Job Name: The Old Power Station Vastern Road
Job No: 47500
Note No: TN004
Date: 9th June 2020
Prepared By: Joe House / Dan Townsend
Subject: RBC Highway Response

This technical note has been prepared by Stantec on behalf of Berkeley Homes (Oxford and Chiltern) Ltd to provide a response to Reading Borough Council (RBC) highway comments provided in the letter dated 28th May 2020.

The comments provided are in response to the full planning application (ref. 200188) for the demolition of existing structures and erection of a series of buildings ranging in height from 1 to 11 storeys, including residential dwellings (C3 use class) and retail floorspace (A3 use class), together with a new north-south pedestrian link, connecting Christchurch Bridge to Vastern Road.

PUMPING APPLIANCE ACCESS TO
BLOCKS D AND EFG - INBOUND

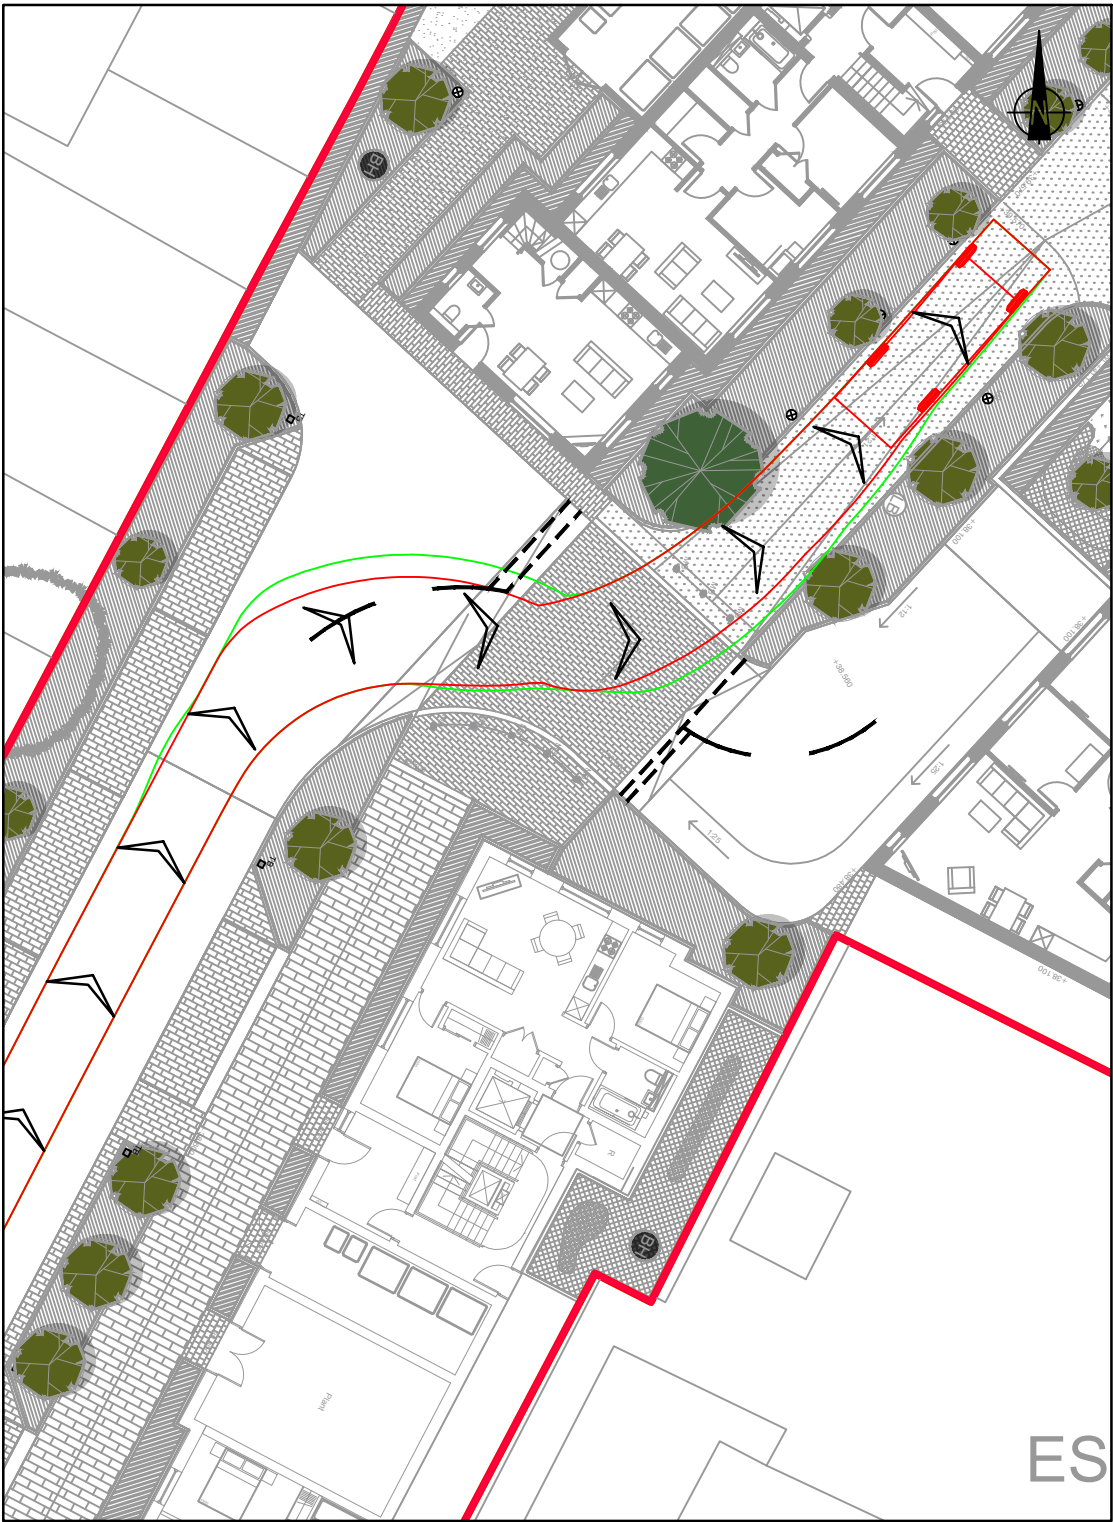
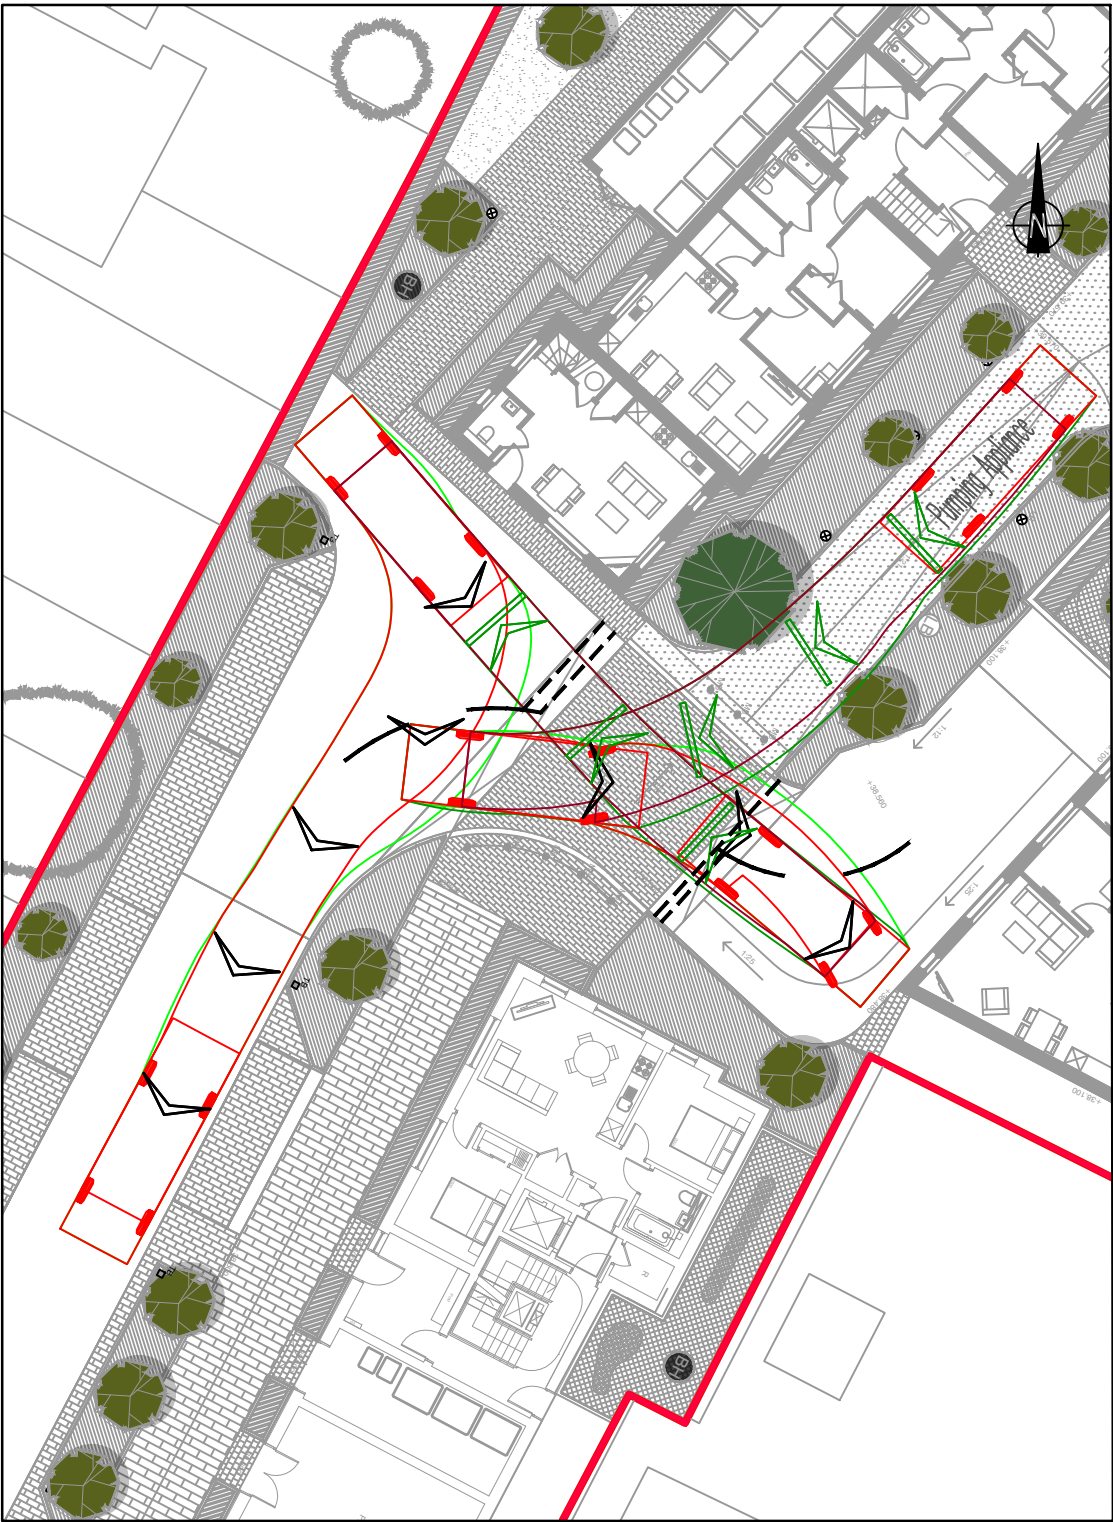
- d) *"The below diagram also identifies the fire strategy for the site which includes the requirement of a fire tender accessing beyond the bollards to the northern section of the dedicated footway / cycleway. However, no tracking diagrams have been provided to confirm that a fire tender could actually get to the area in question, this must therefore be provided."*

Stantec drawing **47500/5500/008** provides the swept path assessment of a 7.9m Fire Pumping Appliance accessing the northern part of the site. The vehicle will be able to mount the foot/cycle path which is circa 3.75m in this location.
